DRB Comments

PROJECT # 1007881

APPLICATION # 09-70235

RE: Lots 1A & 2A, Brentwood Hills Subdivision

Proposed Plat:

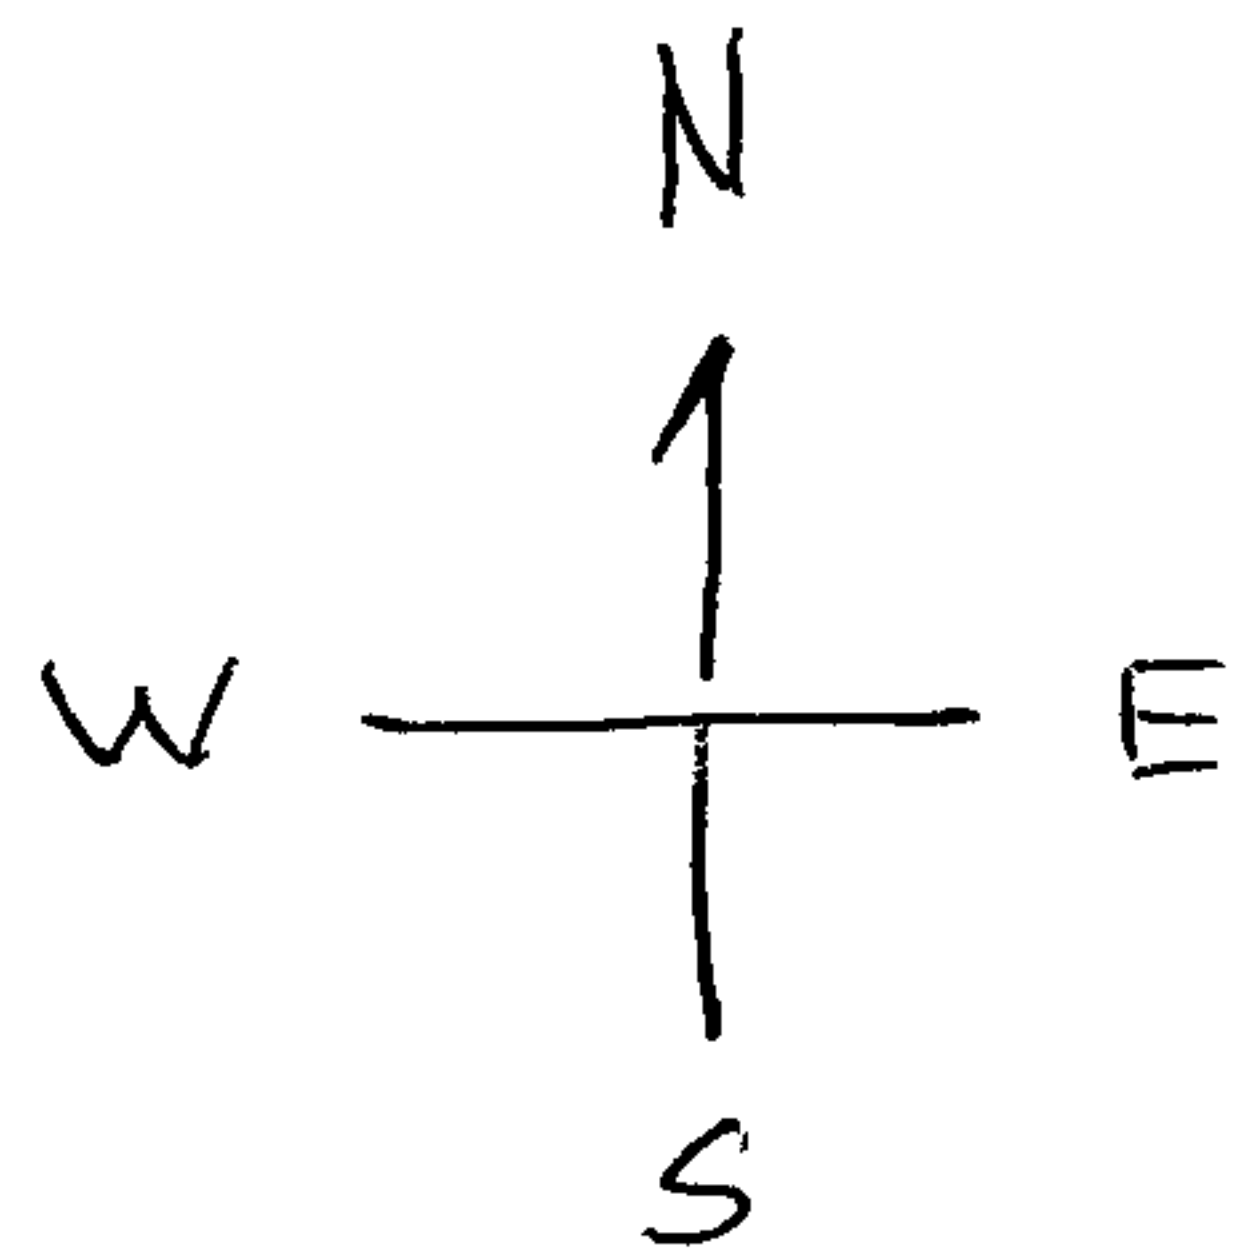
A Zone Change would require an advertised public hearing by the Environmental Planning Commission. Application for zone change requires justification per Resolution 270-1980; it is the burden of an applicant to show why a zone change is appropriate.

If a zone change is approved then a professional land surveyor could be hired to combine the lots with a subdivision plat.
